**ADDENDUM NO. 1**

Project: **STEPHENSON SCHOOL BUILDING & PARKING IMPROVEMENTS**

Owner: **City of Dripping Springs, Texas**

Date: **July 8, 2025**

2 Reflected Ceiling Plan  
1/8" = 1'-0"

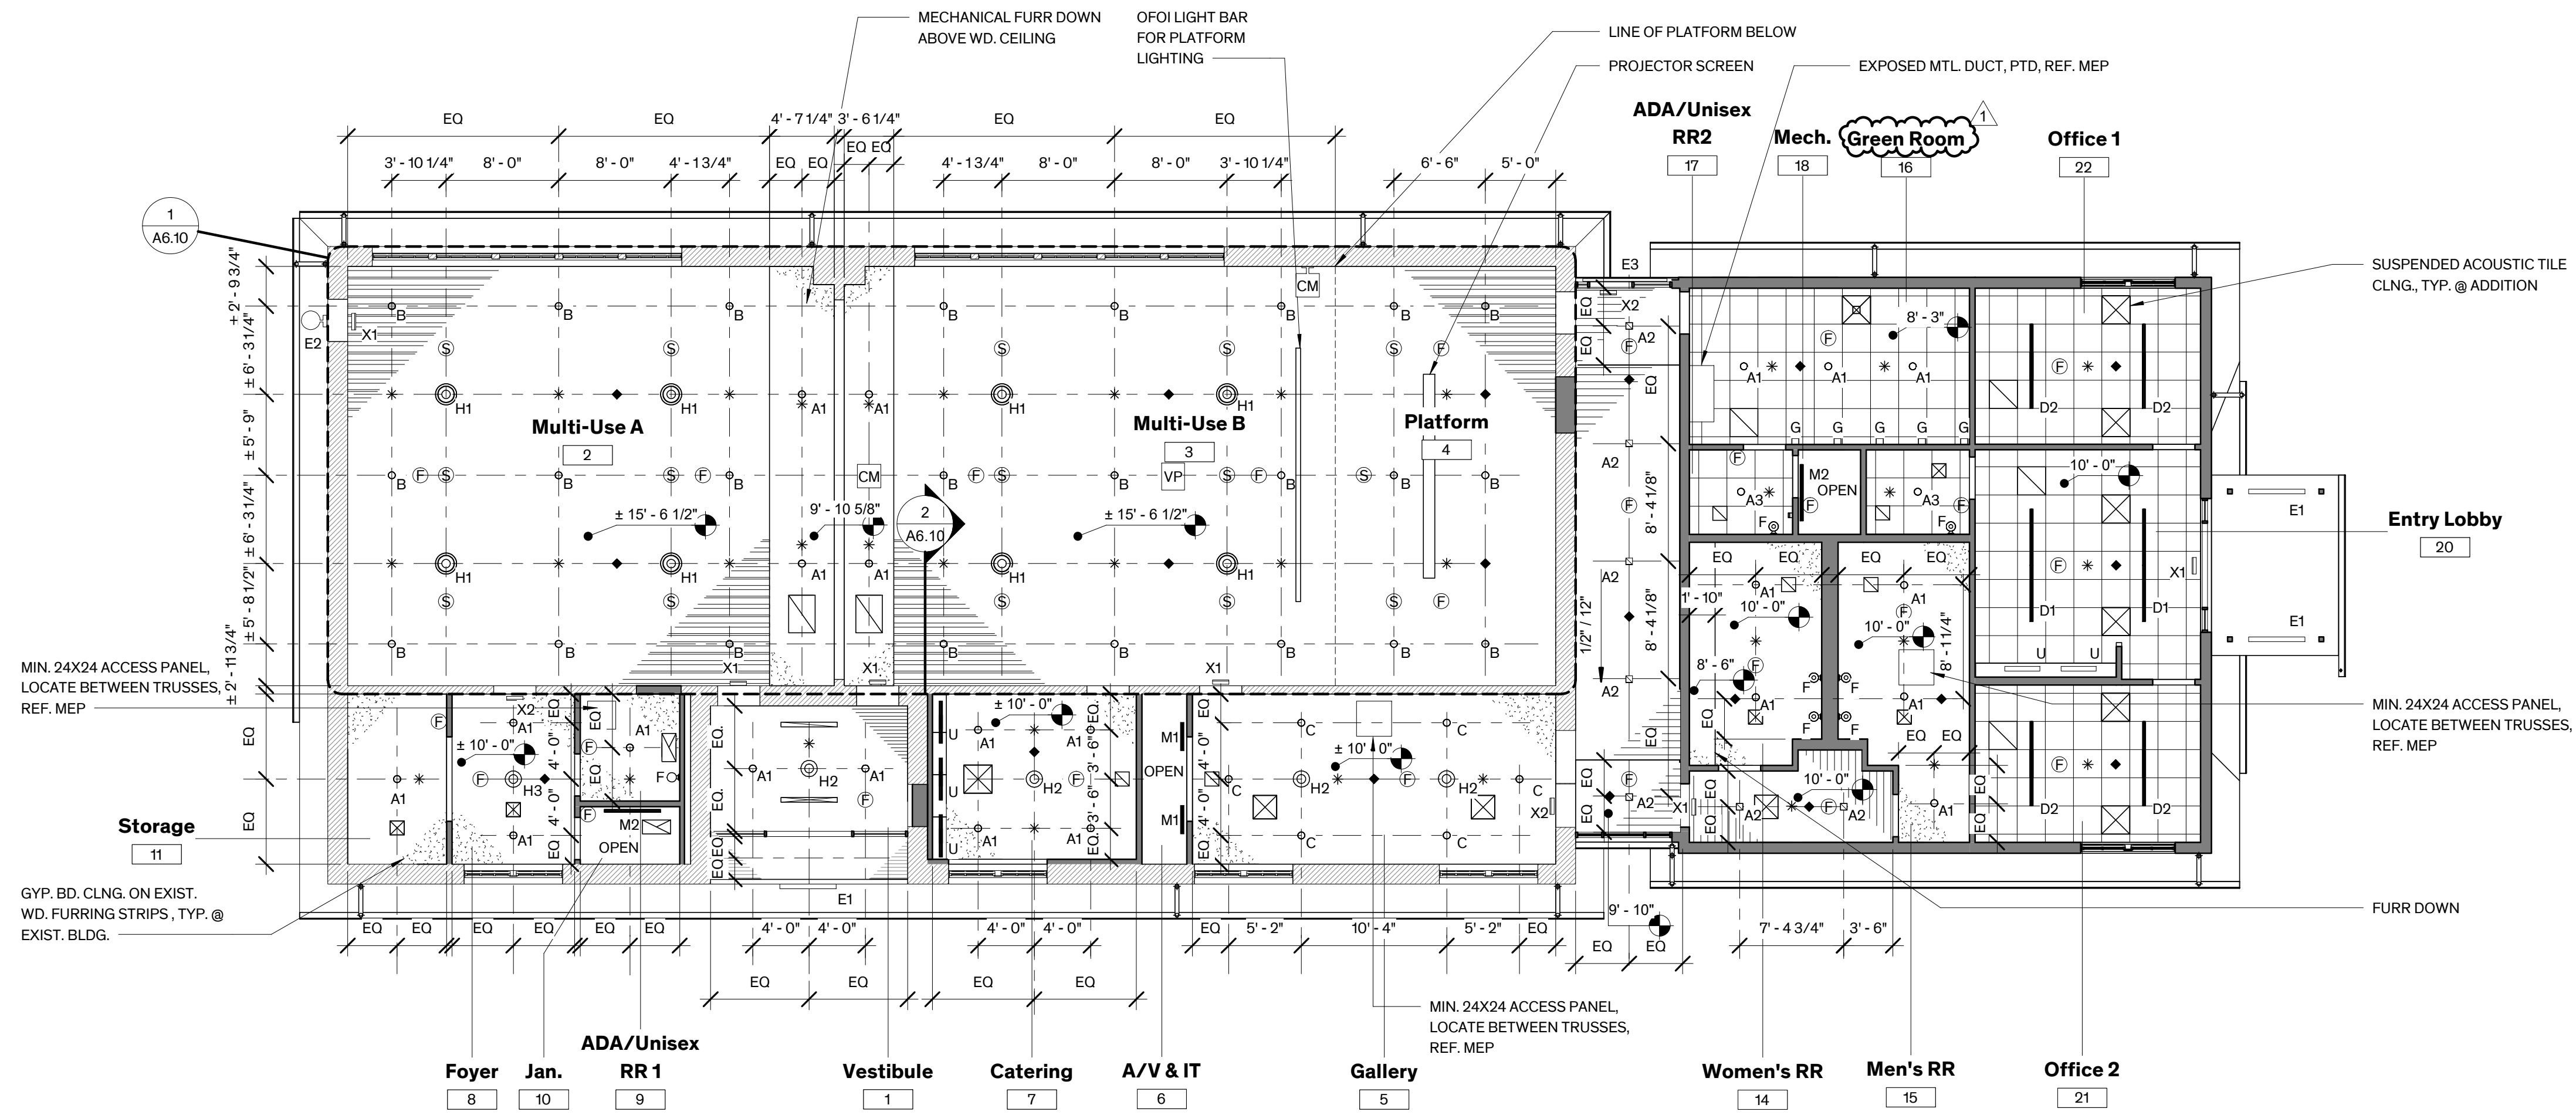
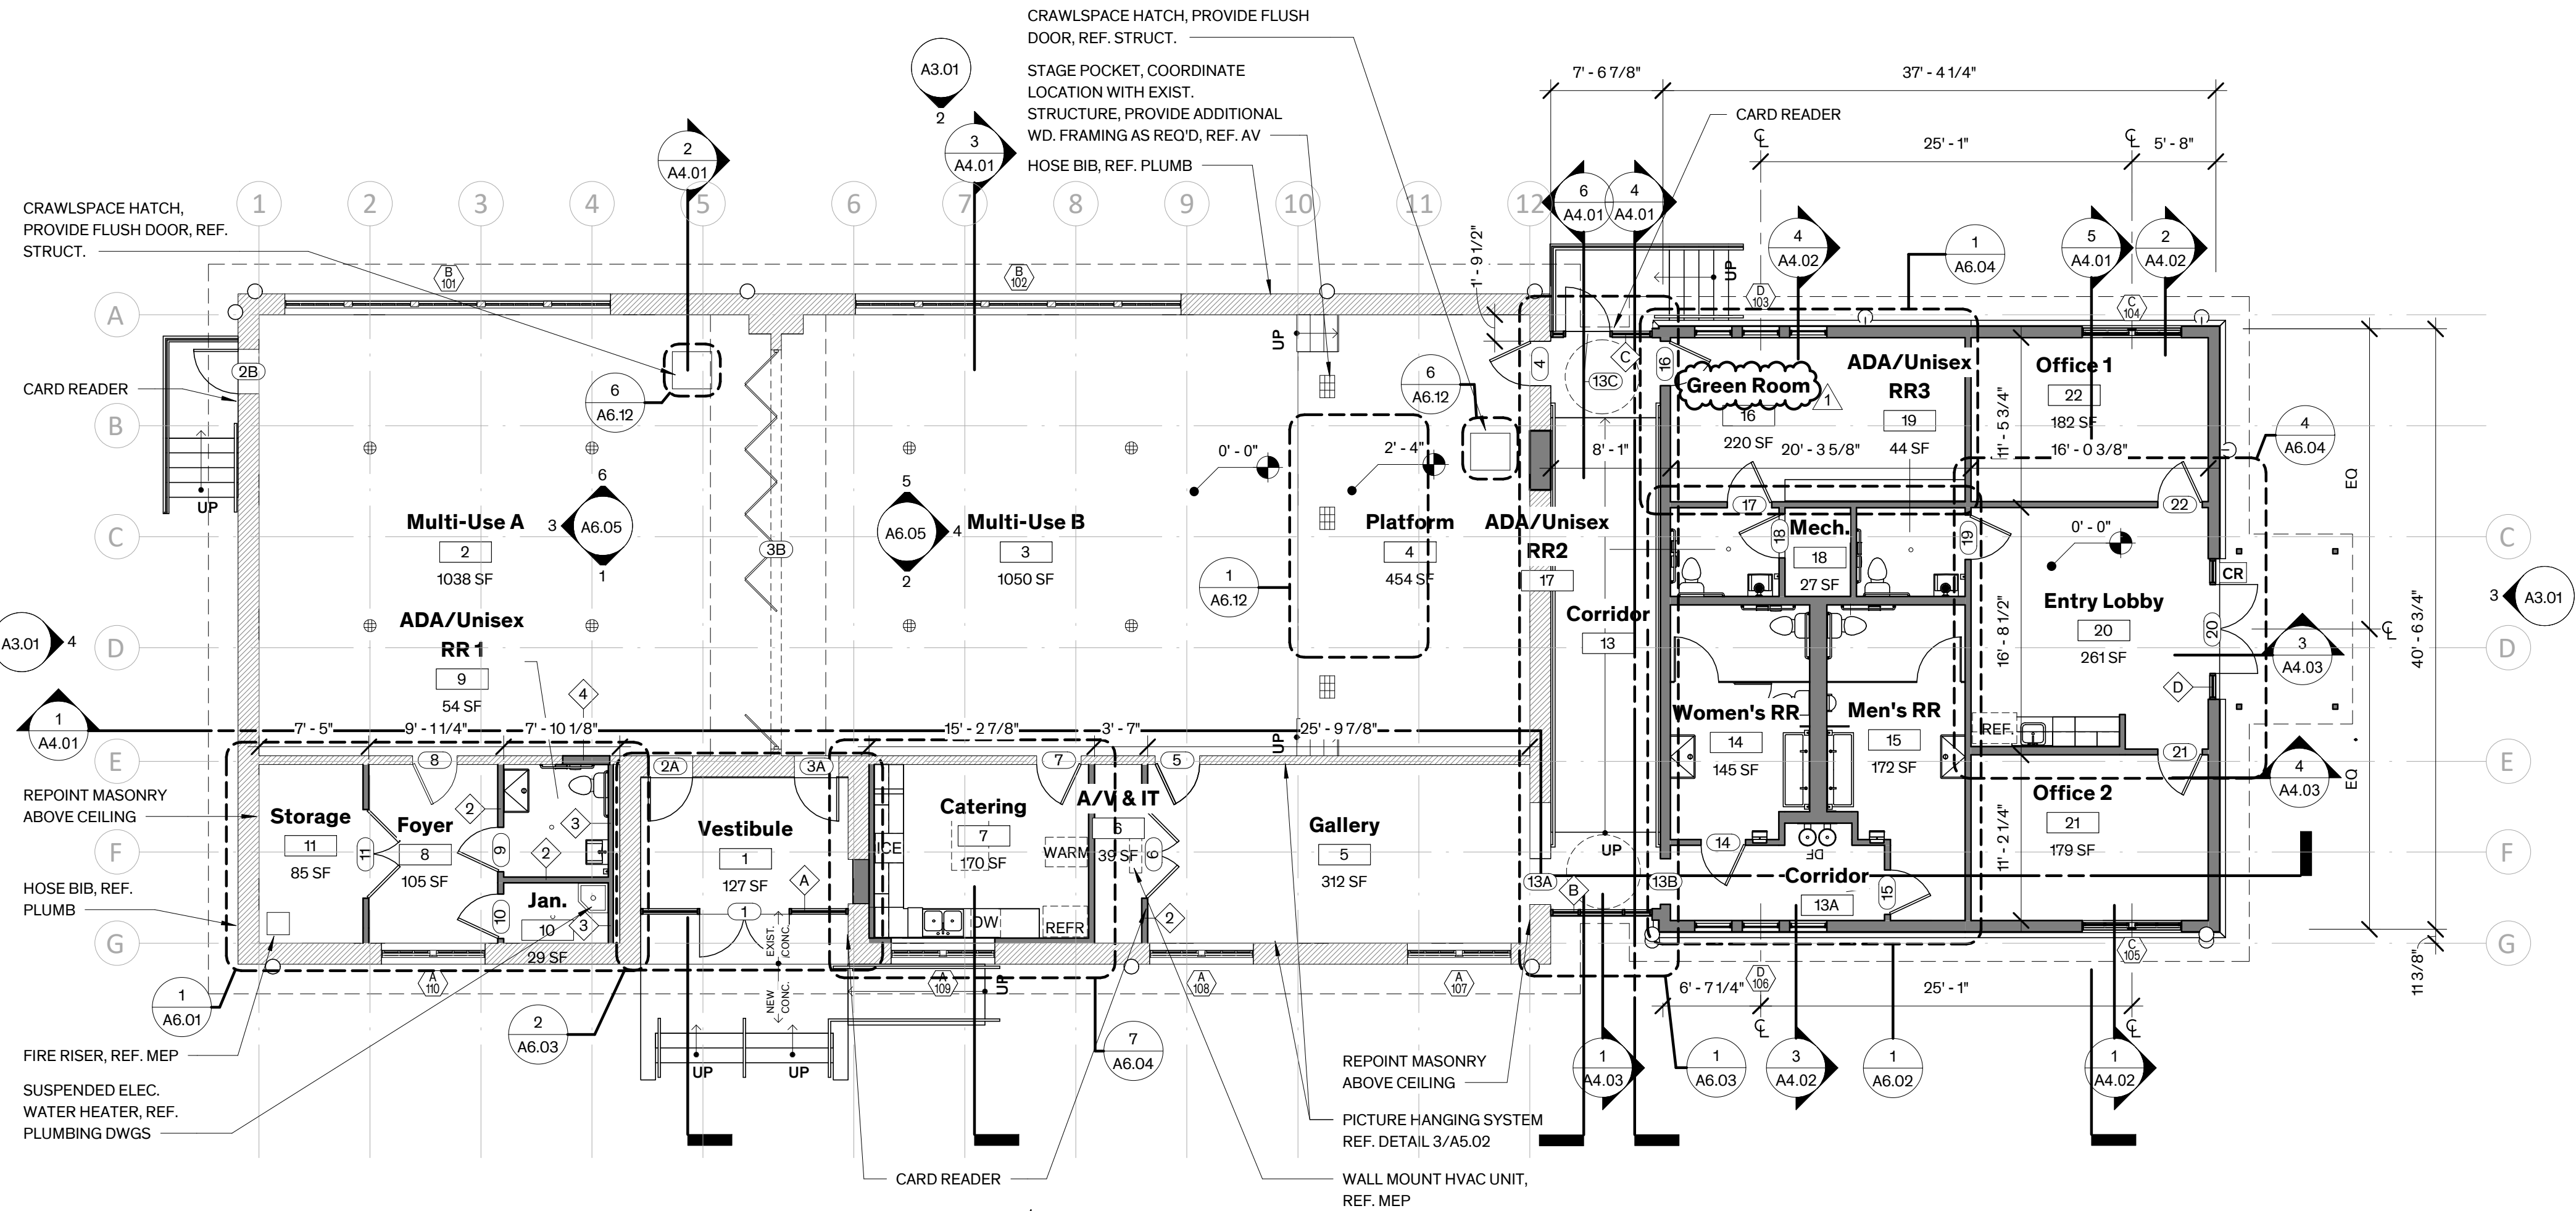
UPDATE – Update room name for Green Room – Room 16.
